**ZONING AMENDMENT,  
& SUBDIVISION STAFF REPORT****Date: December 17, 2009****APPLICANT NAME**

Ball Healthcare Services, Inc.

Twin Oaks Subdivision

## ZONING AND SUBDIVISION DETAIL

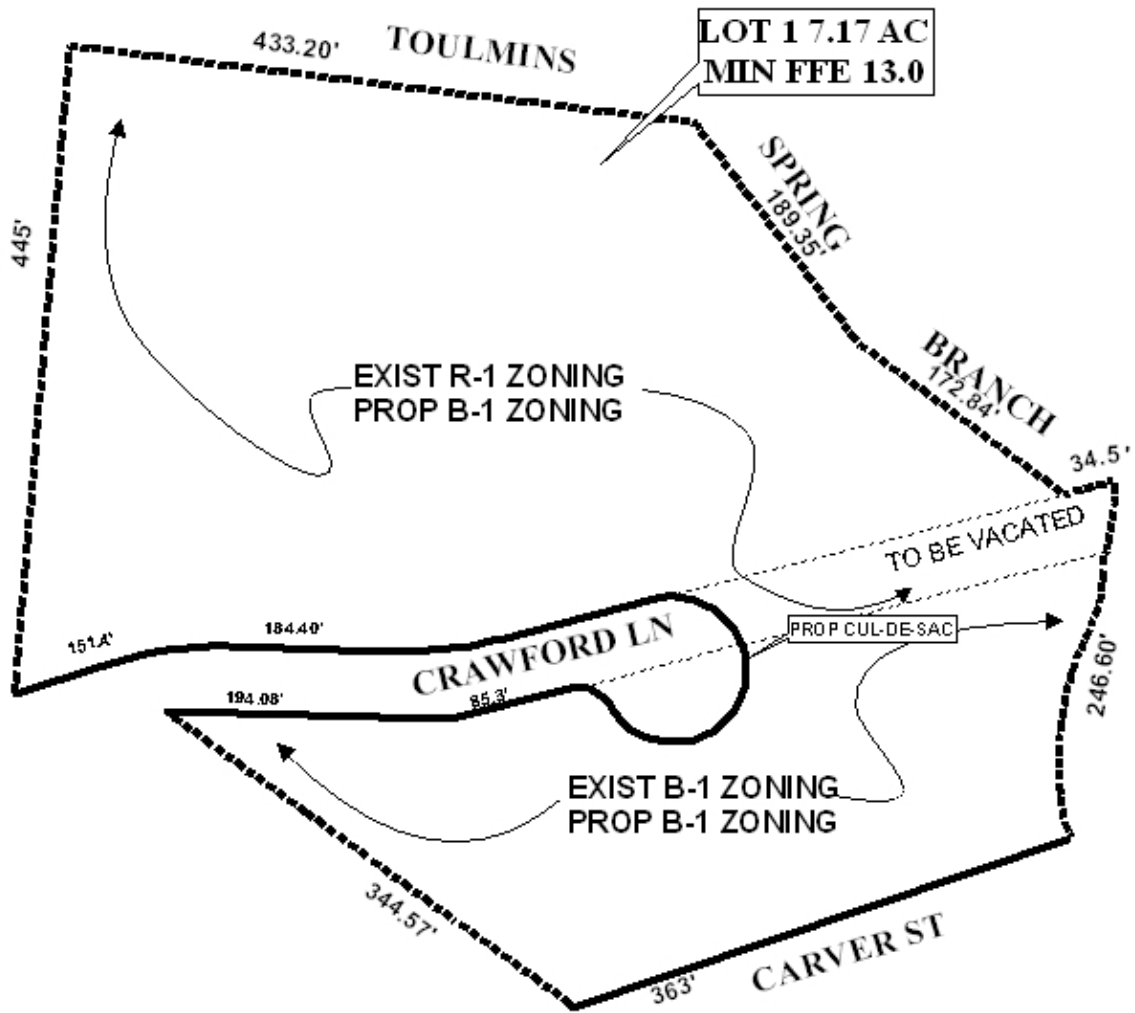
A discrepancy appears between the current application and the application that was approved in 2008. The 2008 application indicates a current right-of-way width of 45.6 feet for Crawford Lane, however the current application indicates a 50-foot right-of-way width. The actual right-of-way width should be noted on the plat and any dedication required be depicted as such.

Crawford Lane is a minor street, provided with curb and gutter and, as per Section V.B.14 of the Subdivision Regulations, requires a right-of-way width of 50 feet. As such, dedication sufficient to provide 25' from centerline along both sides of Crawford Lane should be required.

The cul-de-sac is indicated to be 120' in diameter which meets the requirements of Section V.B.14. Construction of the cul-de-sac to City standards would be required prior to the signing of the final plat.

The subdivision also has frontage along the North side of Carver Street, currently with a 40' right-of-way width; therefore, dedication would be required to provide 25' from the centerline of Carver Street. A 25' minimum building setback line is not indicated along Crawford Lane, and as such should be added and reflect any required dedication.

As a means of access management, a note should be placed on the final plat stating the site is limited to the three existing curb cuts along the North side of Crawford Lane, and two curb cuts along the South side of Crawford Lane, with the size, location and design of all curb cuts to be approved by Traffic Engineering and conform to AASHTO standards. A note should also be required stating that access to Carver Street is denied.

The lot is labeled with its size in acres. This should be revised to indicate the size, in square feet, and be indicated on the final plat, or a table should be furnished providing the same information.

- 1) completion of the Vacation process for the unopened East terminus of Crawford Lane;
- 2) construction of the cul-de-sac to City standards prior to signing the final plat;
- 3) dedication along both sides of Crawford Lane to provide 25' from centerline;
- 4) dedication to provide 25' from the centerline of Carver Street;
- 5) revision of the plat to indicate the 25' minimum building setback line as measured from any required dedication along Crawford Lane and Carver Street;
- 6) placement of a note on the final plat stating that the site is limited to the existing curb cuts on the North side of Crawford Lane, and two curb cuts on the South side of Crawford

- Lane, with the size, location and design of all curb cuts to be approved by Traffic engineering and conform to AASHTO standards;
- 7) placement of a note on the final plat stating that access to Carver Street is denied;

- 9) labeling of the lot with its size in square feet, or the furnishing of a table on the plat providing the same information;
  - 10) compliance with Forestry comments: *Property to be developed in compliance with state and local laws that pertain to tree preservation and protection on both city and private properties (State Act 61-929 and City Code Chapters 57 and 64). Preservation status is to be given to the 60" Live Oak Tree located in front of the existing Structure. Any work on or under this tree is to be permitted and coordinated with Urban Forestry; removal to be permitted only in the case of disease or impending danger;*

# SITE PLAN

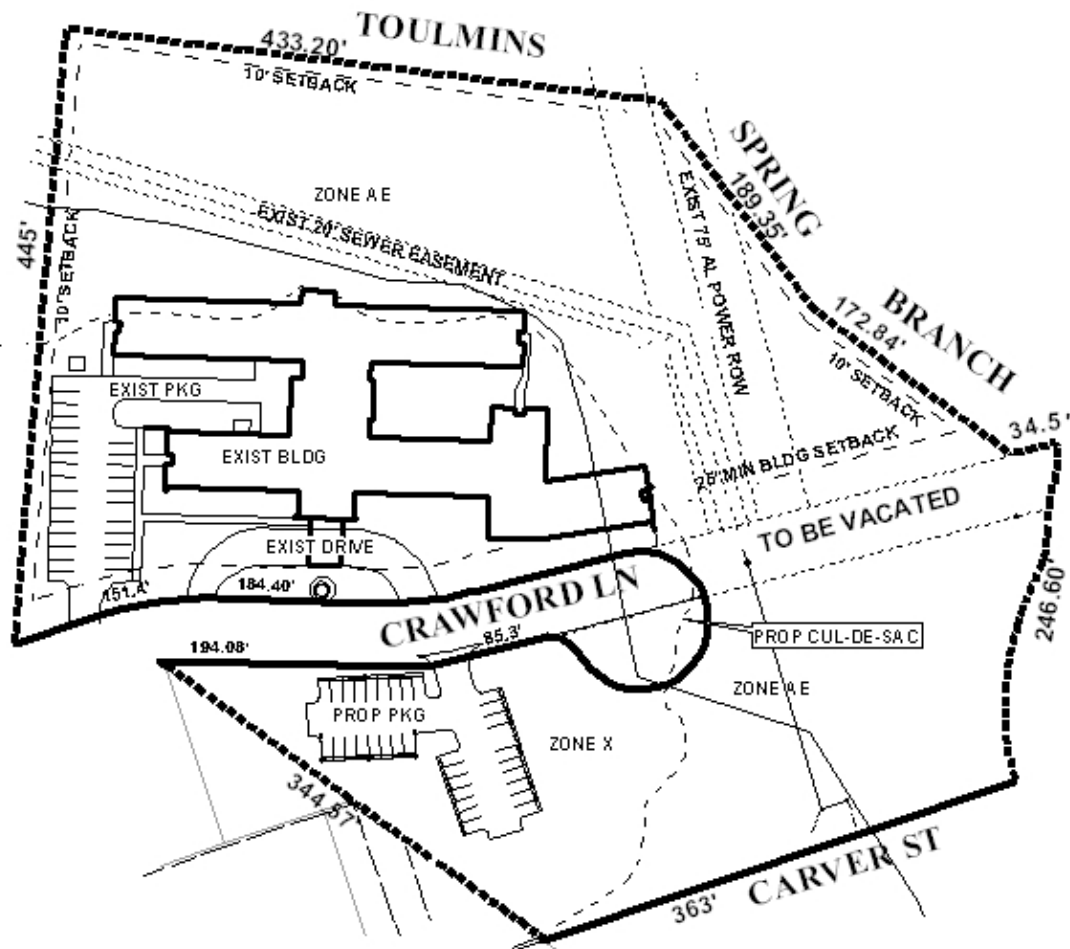
As a new parking area is proposed to be constructed on a site that is currently heavily wooded, compliance with the tree and landscaping ordinance for the site would seem to be appropriate to mitigate the loss of trees in this area. As such, full compliance with the tree and landscaping ordinance should be required as a condition of rezoning.

Lastly, sidewalks will be required along Crawford Lane due to the proposed new parking lot construction. Sidewalks are not indicated on the submitted site plan, but nonetheless must be provided, or a sidewalk waiver be obtained.

- 5) full compliance with tree planting and landscape requirements;
- 6) installation of sidewalks along Crawford Lane, or approval of a sidewalk waiver application by the Planning Commission;
